625 SINGLE TOUCH LEVELING SYSTEM PIGTAIL UPDATE FOR SYSTEMS WITH REMOTE ROCKER SWITCHES

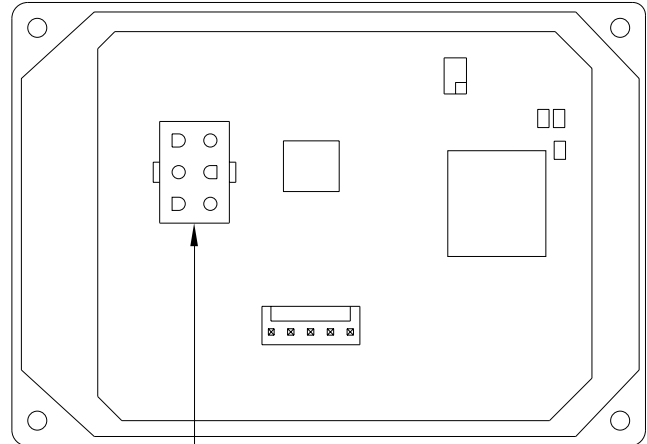
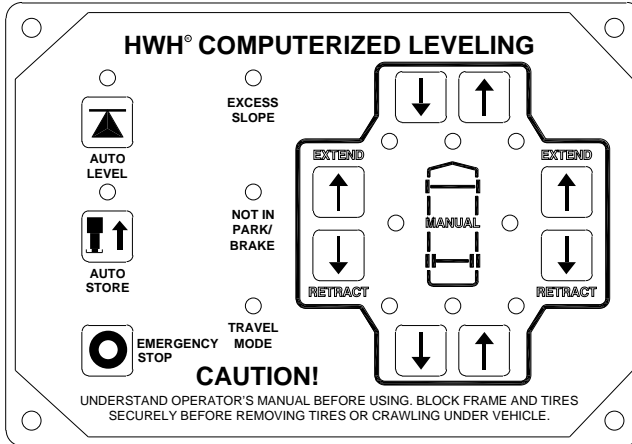
NOTE: ONE TOUCH LEVELING SYSTEMS WITH REMOTE ROCKER SWITCHES MAY EXPERIENCE THE LEVELING SYSTEM SHUTTING OFF DURING AN AUTO LEVEL OR STORE SEQUENCE. THE ADDITION OF THIS PIGTAIL WILL UPDATE THE SYSTEM TO RECTIFY THIS ISSUE.

UNPLUG EXISTING HARNESS AND INSERT PIGTAIL BETWEEN TOUCH PANEL END EXISTING HARNESS.
